25315 - BESD TREMONTON ELEMENTARY
2900 West 500 North Tremonton, UT

Addendum

ADDENDUM 001

Electrical Addendum #1

DIAGRAM V205 MEDIA CENTER AUDIOVISUAL SIGNAL FLOW NTS

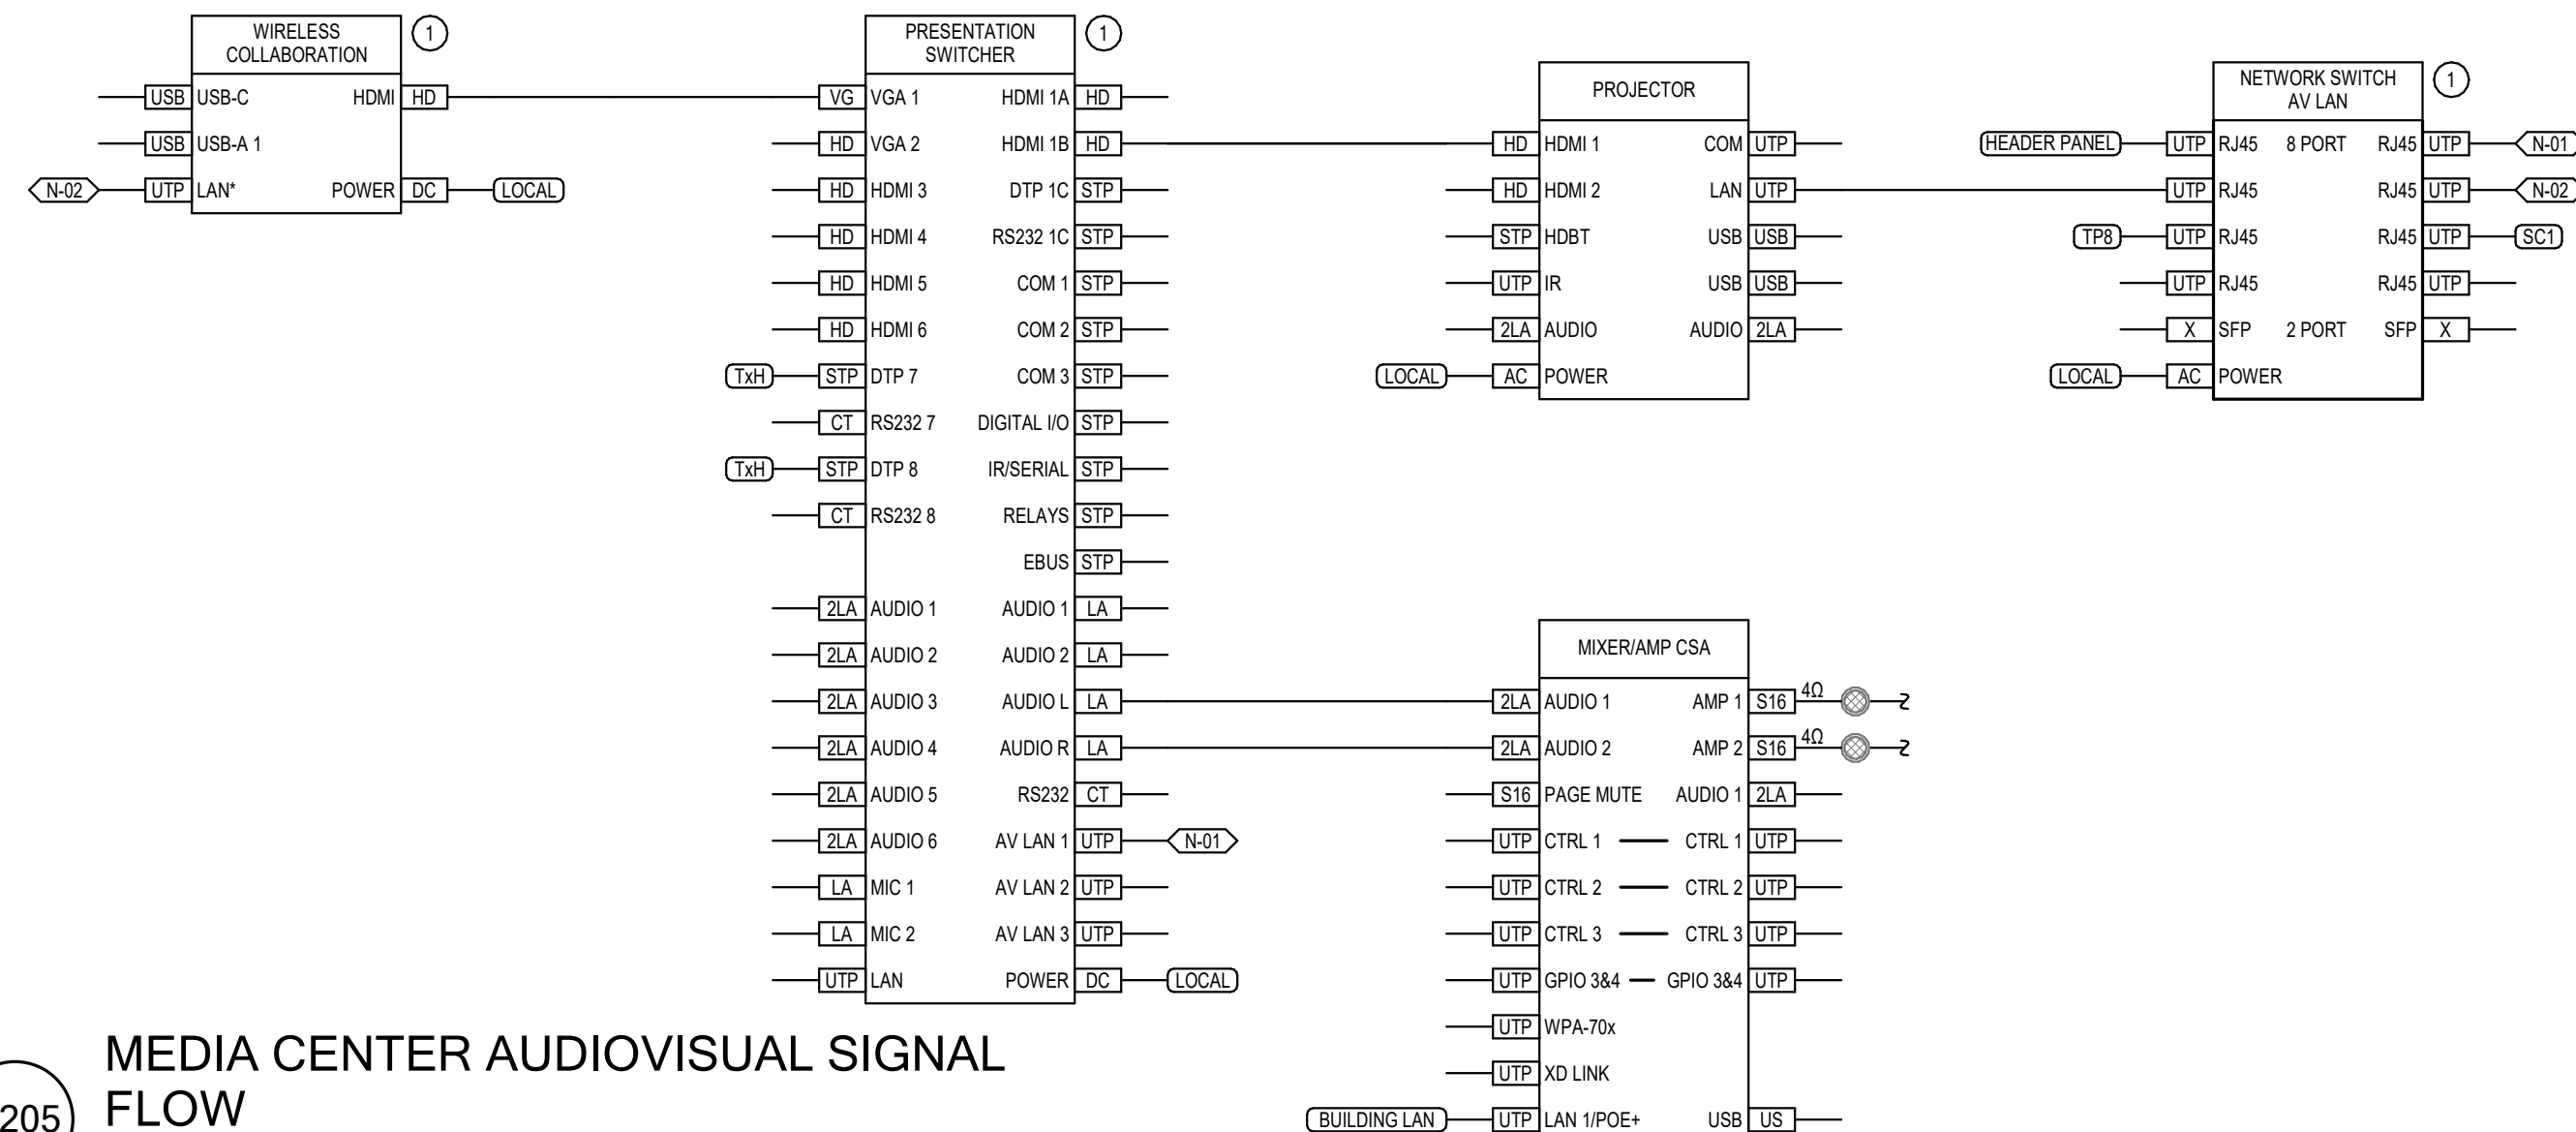
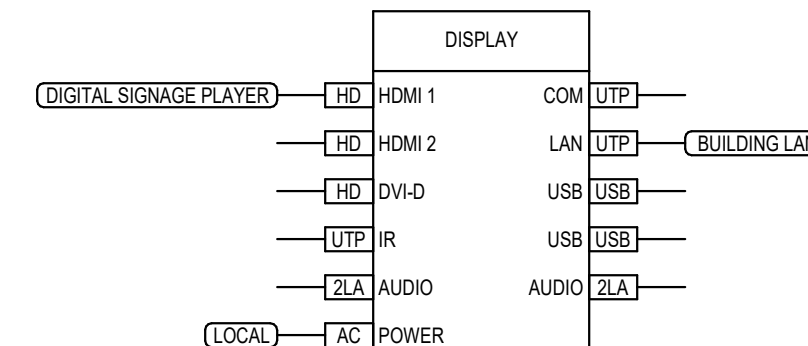
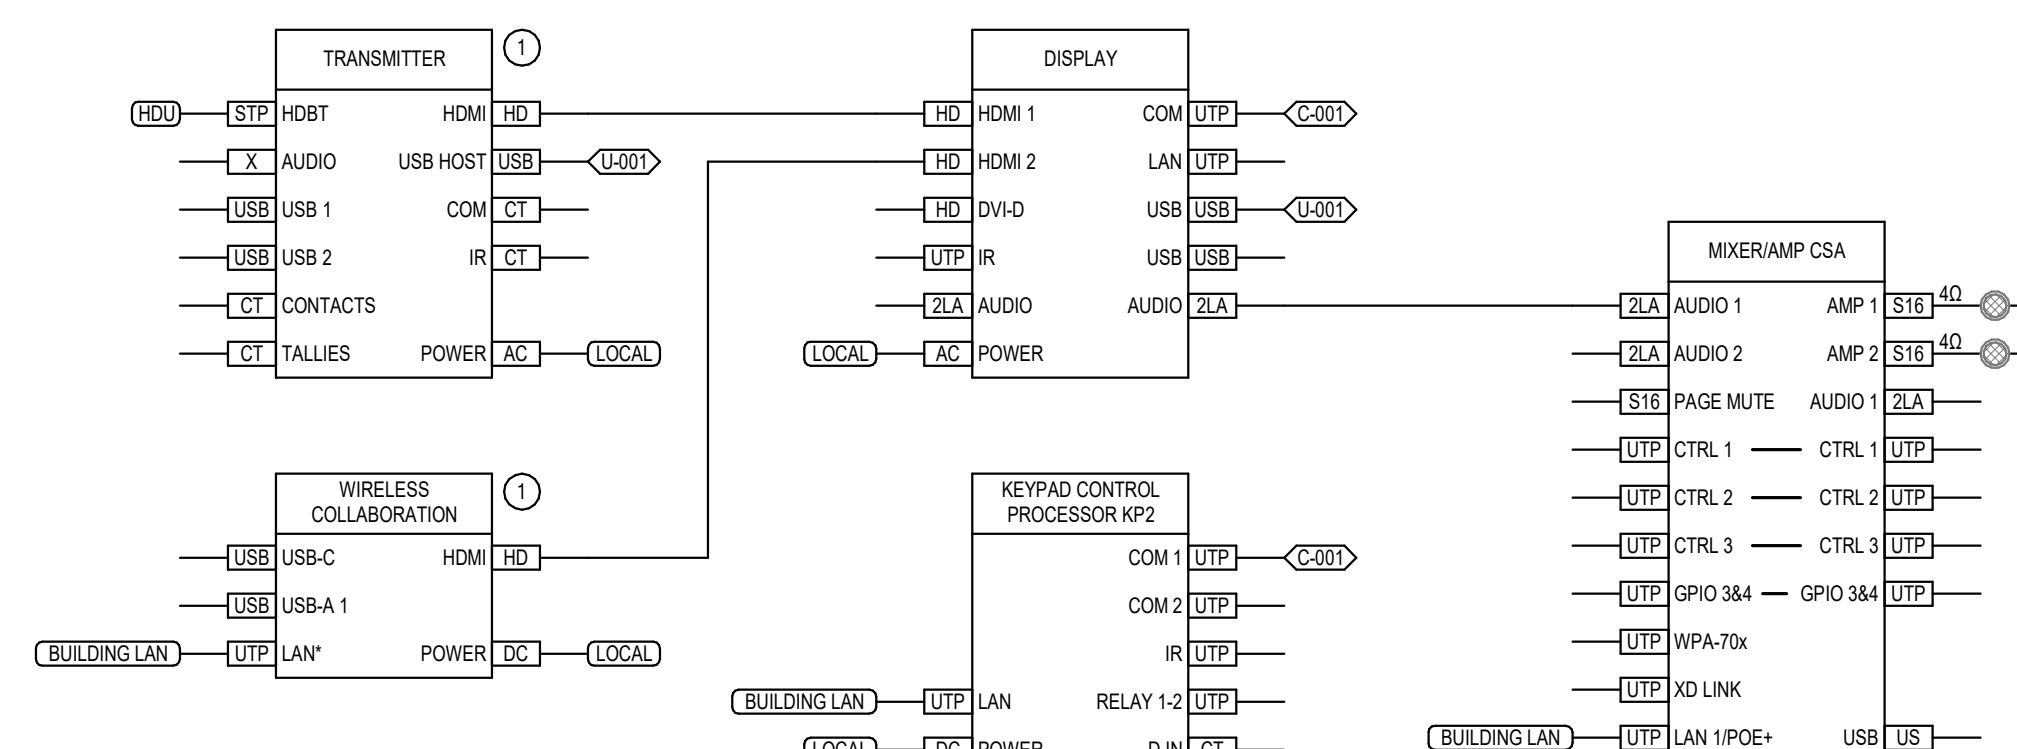
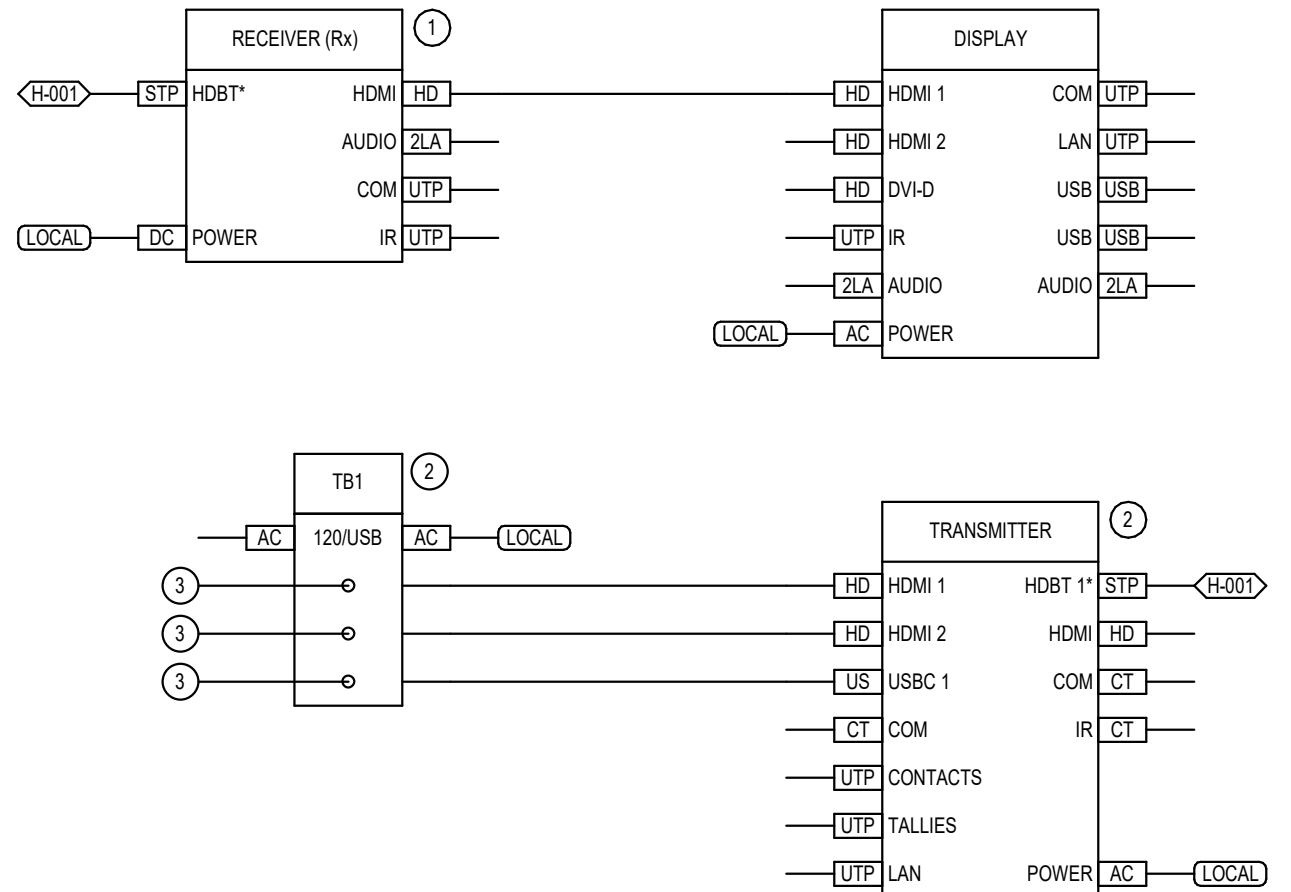
1. See clouded areas on sheet attached.
